1174 Fort – Long Term Care Pharmacy

Site Plan Review

Applicant	Zeinab Dagher
Project	Pharmacy (Long Term Care)
Address	1174 Fort Street, Lincoln Park, MI 48146
Date	December 11, 2019
Request	Site Plan Review
Recommendation	Table

Drawing Title:
 EXISTING FLOOR PLAN

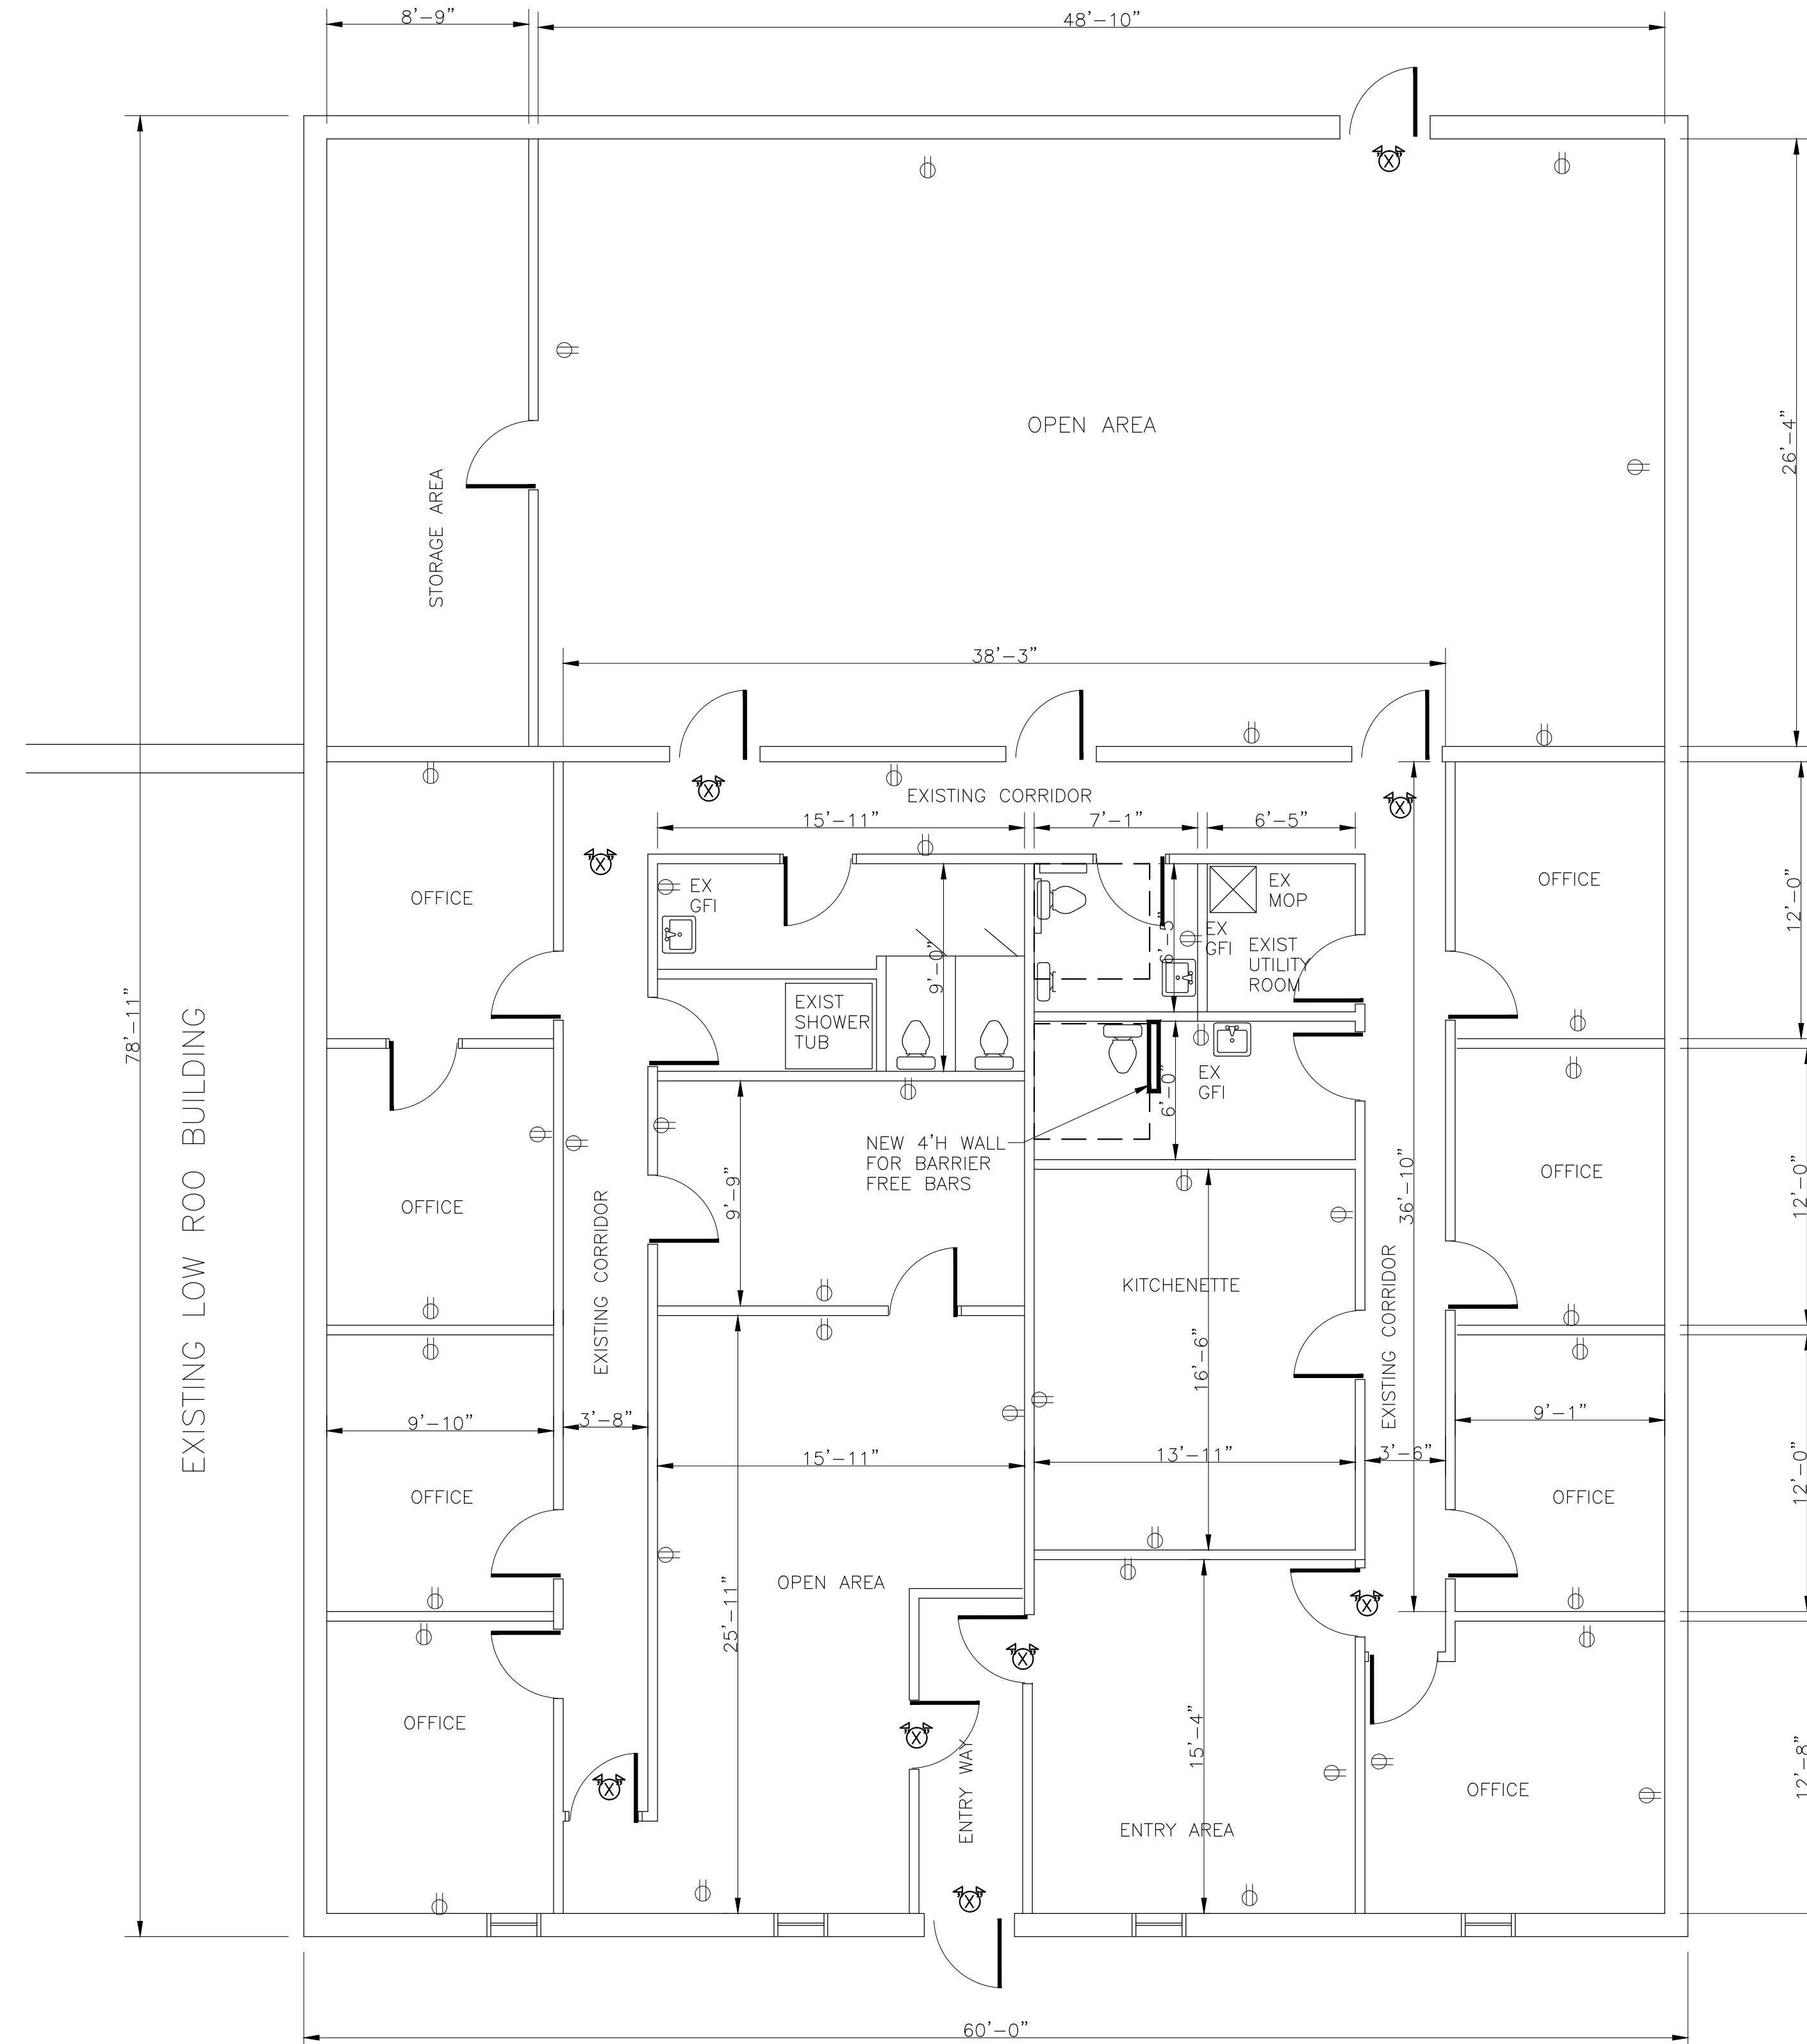
Are all the offices going to be occupied or will they be storage? If they are all occupied it may change the need for additional emergency lighting. There is a symbol for emergency lights but they represent combo lights, please clarify.

1. The door on the south hallway at the southeast area to the hallway exit will need to swing outward.
2. There will need to be one additional emergency light in both the north and south hallways halfway between the combo lights.
3. There needs to be a combo light on the inside of the storage area above the exit going out of the storage area.
4. Will need additional emergency lighting in "open area" on the west side of the building. It's hard to tell how many at this point because there were storage racks and counters there before.
5. Will need emergency lighting in kitchenette area if it's used as a break/kitchen area.

- *Site plan to be evaluated by third party for Fire Code compliance during the detailed engineering review.*
- *Applicant shall investigate and arrange to permit necessary emergency vehicle access as required by the Fire Department and Police Department.*
- *The following comments will be addressed during the Building Department's review*
 - *Applicant to clarify the use of offices*
 - *Door on south hallway at southeast area to the hallway exit to swing outward.*
 - *One additional emergency light in both the north and south hallways halfway between the combo lights.*
 - *Combo light on the inside of the storage area above the exit going out of the storage area.*
 - *Additional emergency lighting in "open area" on the west side of the building; determine quantity in conjunction with the Fire Department.*
 - *Emergency lighting in kitchenette area if it's used as a break/kitchen area.*

Drawing Title:
ELEVATIONS

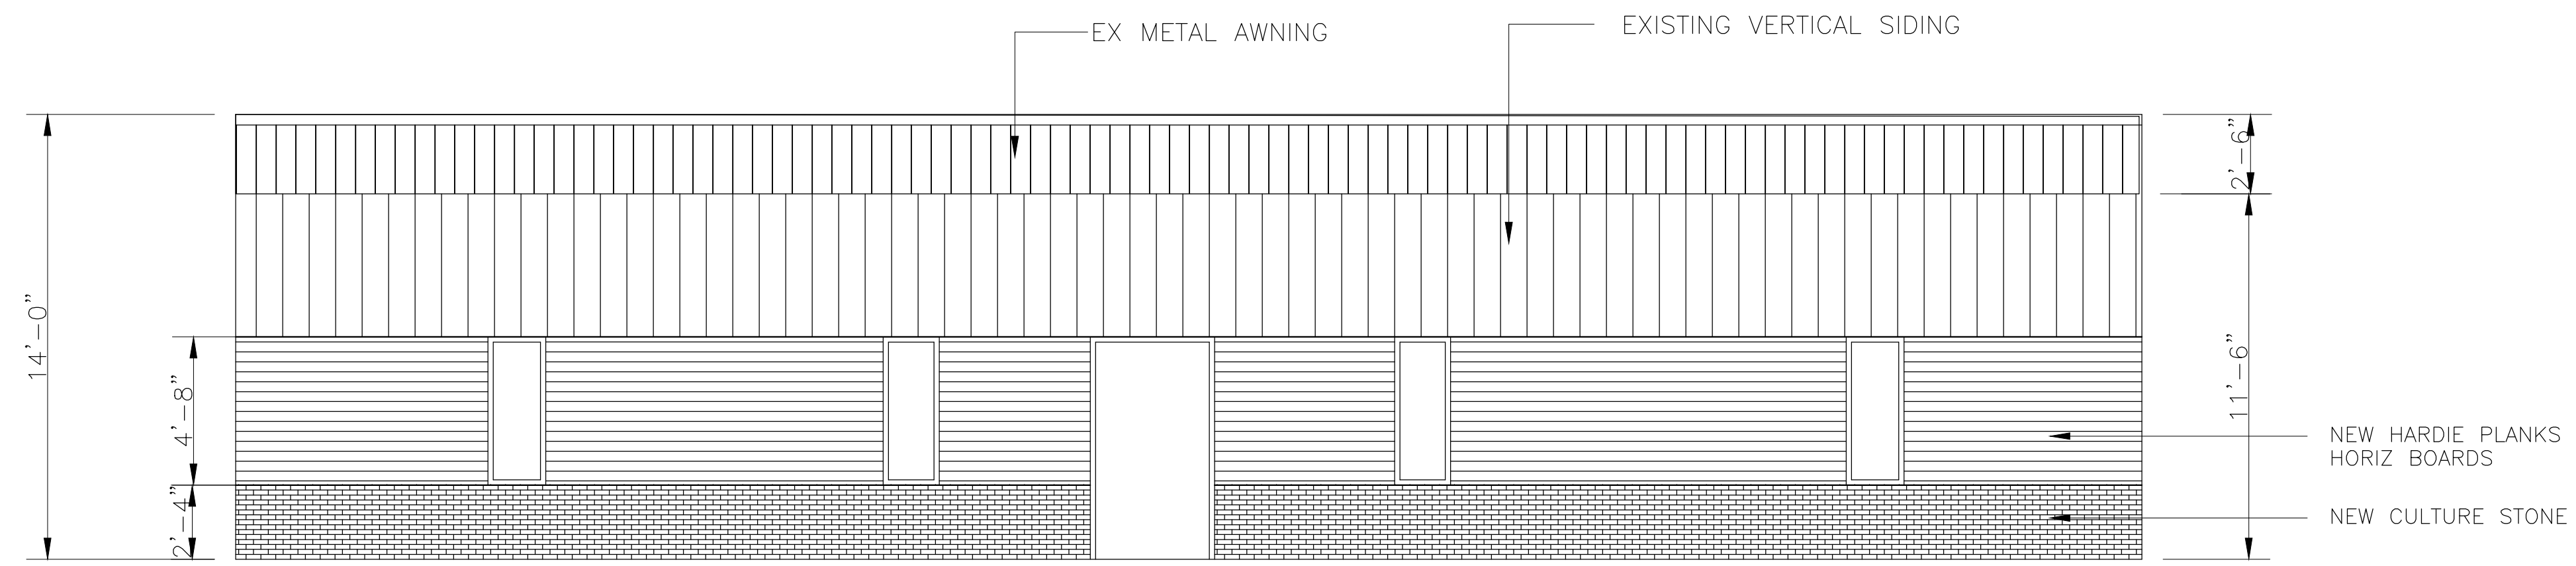
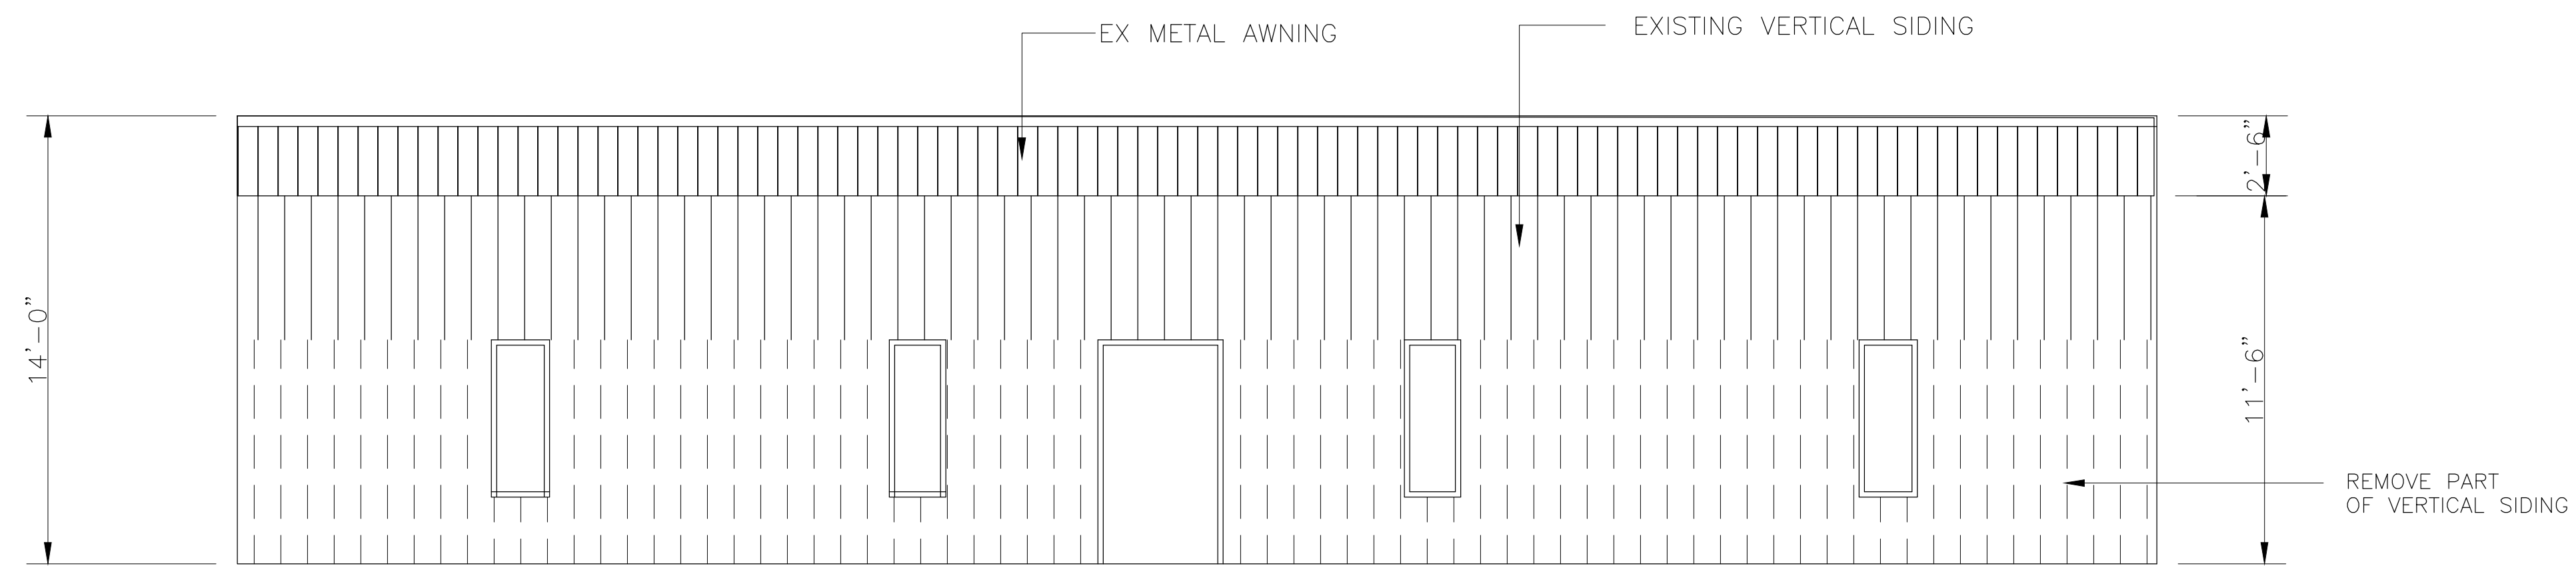
The applicant has proposed some improvements to the façade intended to demonstrate progress toward the requirements of Section 1296.04. The two most significant deficiencies in the existing building are the façade material, which currently consists of a metal awning and unidentified siding, and the window requirement. The applicant has proposed to change the material on approximately half of the front façade, and has made no proposal to improve the window configuration. However, only one of the two materials proposed for replacement meets the code (cultured stone), so the net effect toward compliance is lessened. Ideally, it would be the City’s preference to extend the cultured stone up to the retained material, and to reduce the additional square footage of this improvement by expanding the window area. At a minimum, it is the City’s preference for the applicant to retain the cultured stone, and to address the window requirement rather than substituting one non-compliant material for another. **Because this item is at the Planning Commission’s discretion, the final design shall be approved by the PC.** A revised colored elevation containing all of the information described below may be submitted to the planning consultant in advance of the meeting for presentation to the Commission; alternately, the vote may be tabled pending receipt of a revised proposal.

- Applicant shall provide elevations showing the colors of the proposed new materials and any other proposed changes to exterior color
- Applicant shall indicate a clear description of the unidentified material of the existing vertical siding of the front façade.

- Applicant shall work with the Planning Commission on the desired improvements of the front façade to meet the building material and window requirements.
- Applicant shall provide adequate protective screening for the roof-top mechanical equipment.
- The Planning Commission to determine whether the proposed use of the LTC pharmacy fits the intent of land uses within the NBD.
